190 Goldhurst Terrace
London, NW6 3HN

Basement Impact Assessment
Audit

For
London Borough of Camden

Project Number: 13693-41
Revision: F1

190 Goldhurst Terrace NW6

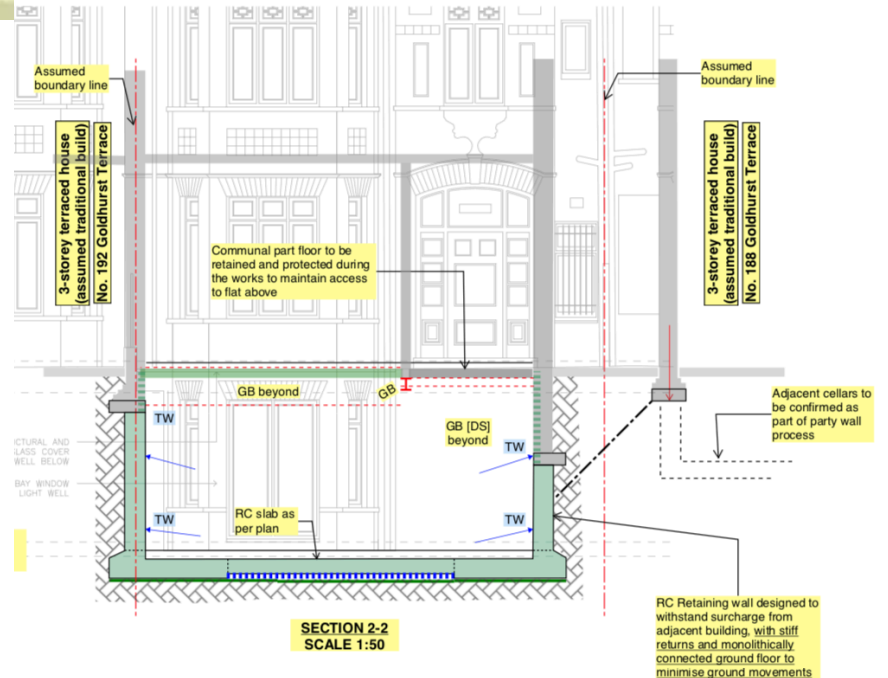
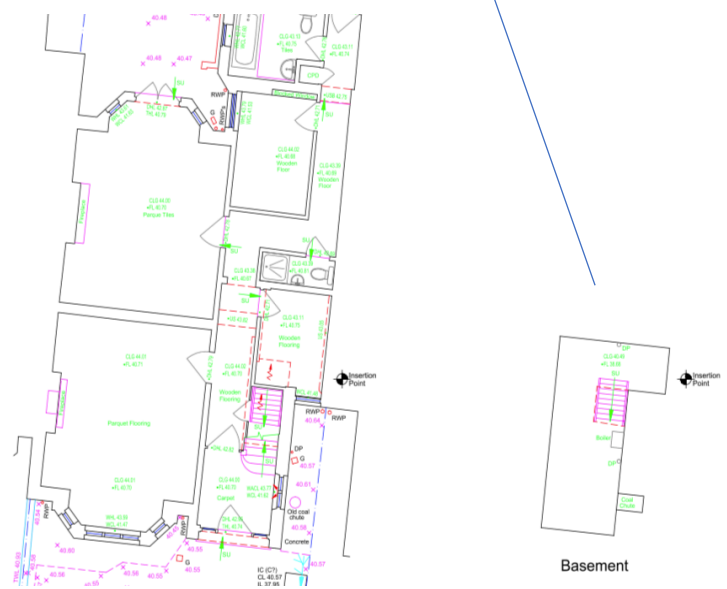
Query 2 - The GMA should include all the walls within the zone of influence of the proposed basement and a plan showing the geometry of the proposed excavation in respect to the neighbouring walls should be presented for clarity. The full input and output of the software used in the GMA should be presented.

The full inputs / outputs of the PDisp model are provided (as attached). However, please note that as section 10.6.7 of the BIA, although a detailed sequential model has been assessed in PDisp for the purposes of predicting heave / settlement specific to the changes in load generated during the proposed construction sequence, the GMA and damage assessment is based upon the "low stiffness" movement curve in CIRIA C760 (Figure 6.15b) and predicts settlements at the wall of >12mm. This is significantly more conservative than the PDisp movements predicted and, given that the temporary works requires propping and is specified to be propped by the Structural Engineer in the submitted drawings, typically the movements would be expected to fall within the "high stiffness" range predicted by CIRIA C760 ie the assessment is reasonably conservative.

In addition, the assessment focusses on the structural walls to adjacent properties where greatest movements are predicted ie adjacent to deepest excavations. Note that the adjacent properties also have cellars which would mitigate impacts (ie differential depth in foundations between proposed basement / adjacent cellars is reduced) across portions of the buildings' footprints and the existing cellar at the site limits the excavation requirements across part of the site (ie reduces potential for generating movements). On the basis that the walls of the adjacent structures at the locations where greatest movements are being generated have been assessed conservatively, demonstrating that a maximum of Burland

category 1 damage will be sustained, the remaining walls within the adjacent properties will clearly be less impacted and fall within the CPG Basements / Policy A5 maximum damage policy criteria; therefore, a full analysis of all the walls is not presented.

Monitoring of Movements as BIA:

- Amber Trigger 5mm
- Red Trigger 8mm
